## ALARIS CONCEPTS

### Kaddy Bracket™ ATV Design Modification

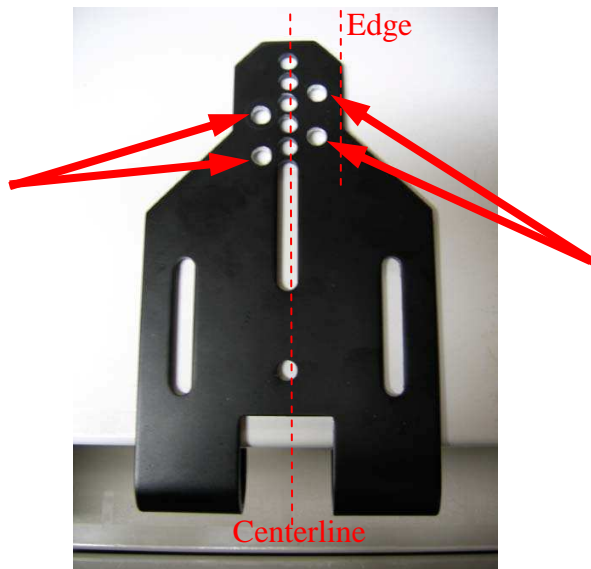
It has come to my attention that the mounting of Kaddy Bracket ATV (quad bracket) is meeting with some difficulty on a select group of tubular quad racks. It seems that the ideal J-Bolt hole location in a minority of cases is somewhere between the holes that currently exist in the aluminum plate. To rectify this, I have modified the design slightly as shown in the photo below. If you are experiencing difficulty in getting a secure fit in the chosen location on your quad rack, I would suggest the following modification:

*Using a high-speed drill, add extra  $21/64$ " holes as required in these locations (staggered between existing holes, halfway between centerline and edge of plate).*
